V2500-A1/A5 SERIES PROPULSION SYSTEMS SERVICE BULLETIN

This document transmits Revision 4 to Service Bulletin EV2500-75-0060 and
 Revision 4 to the Supplement

AIR-ACTIVE CLEARANCE CONTROL SYSTEM – INTRODUCTION OF REVISED (ACC) MOUNTING BRACKET
AND LINK ASSEMBLIES WITH SLOTTED ENTRY BEARINGS

General View
Figure 1

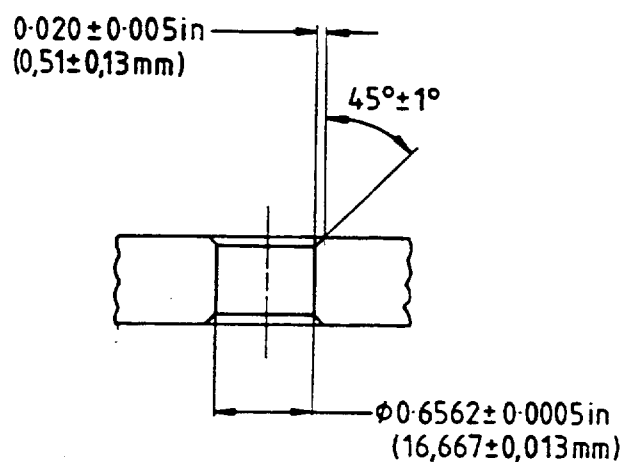
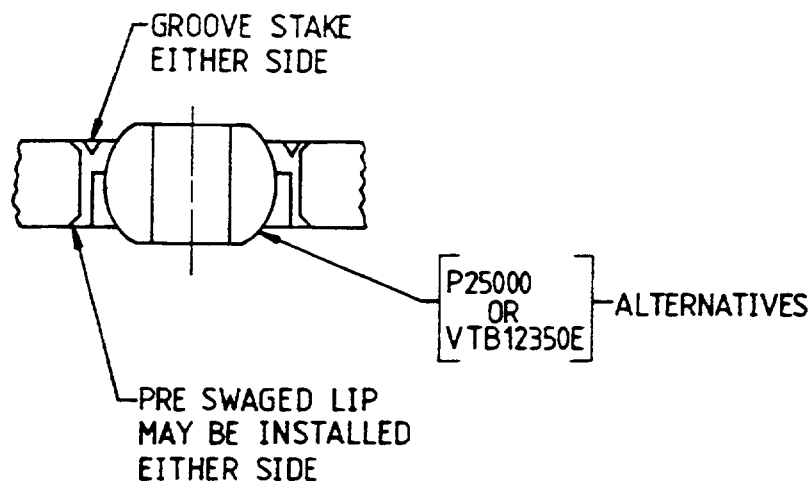
(1) The ACC bracket and link assemblies have been revised, the changes are as follows:

(a) To allow the replacement of worn bearings without the complete removal of the bracket or link assembly, the entry spherical bearings are now slotted.

Installation of spherical bearings - Assemblies 6A6487, 6A6489, 6A6490 and 6A6491
Figure 2

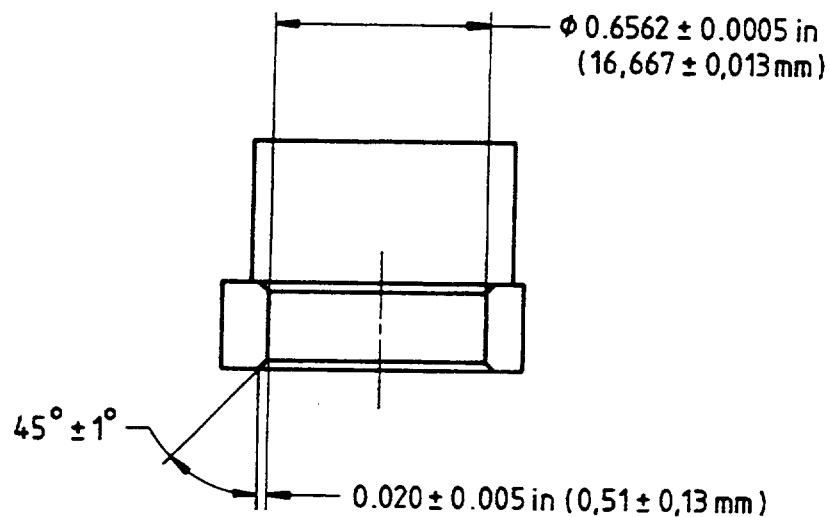
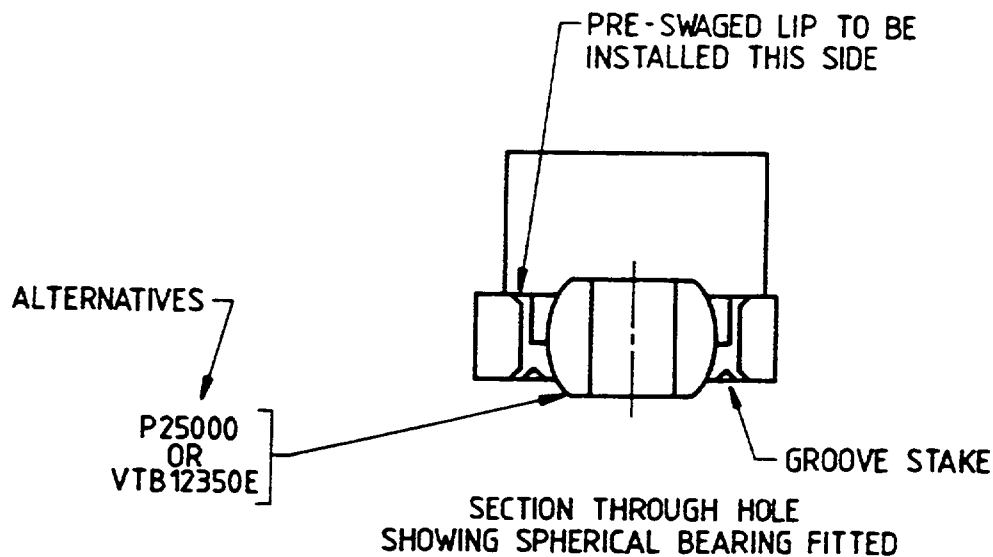
(c) Remove the bearing (Method 1)

If necessary use an IAE trepanning cutter or suitable equivalent, with a vertical milling machine (Refer to Figure 2)

Use a press with standard workshop equipment. Use a pressure of 15 psi (1 bar) (100 kPa). Make sure the bracket assembly is held correctly (Refer to Figure 2).

- (h) Visually examine and measure the dimensions of the bearing location hole

| (i) Install the new bearing in the bracket assemblies | For part number 5W2099 use VTB12350E bearing assembly 05-505 or P25000 bearing assembly 05-505.

For part number 5W2237 use VTB12350E bearing assembly 05-582 or P25000 bearing assembly 05-582 (Refer to Figure 2). |

| (j) Swage the new bearing in to the bracket assemblies | Use a swaging tool available from the bearing supplier (Refer to the Standard Practices Manual (SPM), TASK 70-42-06-400-501, SUBTASK 70-42-06-400-004).(Refer to Figure 2). |

Installation of spherical bearings - Assembly 6A6488
Figure 3

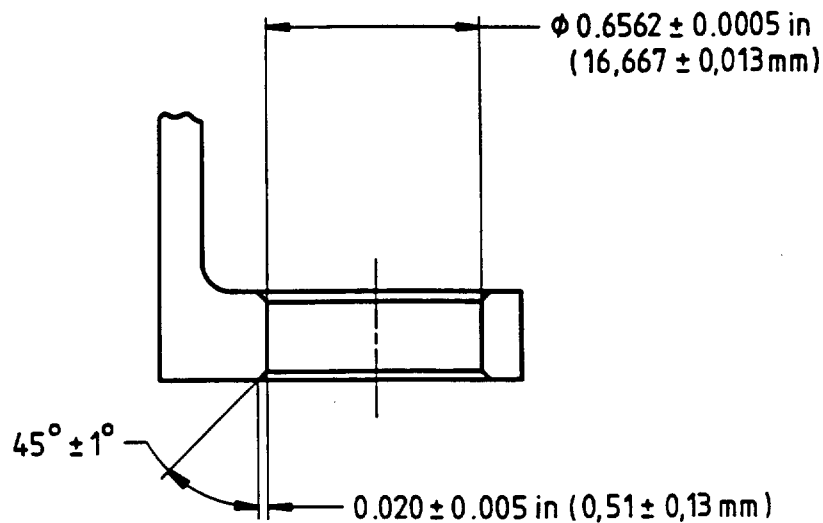
- (i) Install the stator rod assembly or link assemblies in the vertical milling machine
- Use a vertical milling machine with standard workshop equipment (Refer to Figure 2 or 3)

- (ii) Machine the lip of the bearing(s) to be removed
- If necessary use an IAE trepanning cutter or suitable equivalent, with a vertical milling machine (Refer to Figure 2 or 3)

- (i) If cracks are found, reject the part(s).
- (h) Visually examine and measure the dimensions of the bearing location hole
- Use workshop inspection equipment (Refer to Figure 2 or 3).

- (i) Install the new bearing in the stator rod or link assemblies
- For part number 5W2096 use VTB12350E bearing assembly 01-820 or P25000 bearing assembly 01-820 (Refer to Figure 2 and 3).
For part number 5W2239 use VTB12350E bearing assembly 02-180 or P25000 bearing assembly 02-180 (Refer to Figure 2 and 3).
For part number 5W2235 use VTB12350E bearing assembly 02-330 or P25000 bearing assembly 02-330 (Refer to Figure 2 and 3).

Installation of spherical bearings - Assembly 6A6486
Figure 4

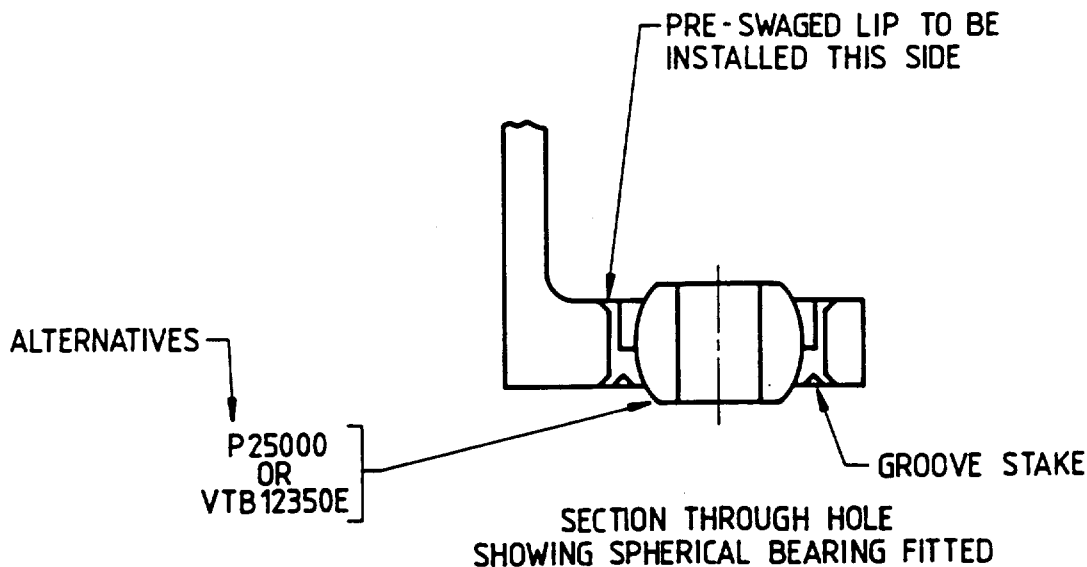
Use a vertical milling machine with standard workshop equipment (Refer to Figure 4)

If necessary use an IAE trepanning cutter or suitable equivalent, with a vertical milling machine (Refer to Figure 4)

| (h) Visually examine and measure the dimensions of the bearing location hole | Use workshop inspection equipment (Refer to Figure 4). |
| (i) Install the new bearing in the bracket assemblies | For part number 5W20998 use VTB12350E bearing assembly 01-530 or P25000 bearing assembly 01-530 (Refer to Figure 4). |
| (j) Swage the new bearing in to the bracket assemblies | Use a swaging tool available from the bearing supplier (Refer to the Standard Practices Manual (SPM), TASK 70-42-06-400-501, SUBTASK 70-42-06-400-004). (Refer to Figure 4). |
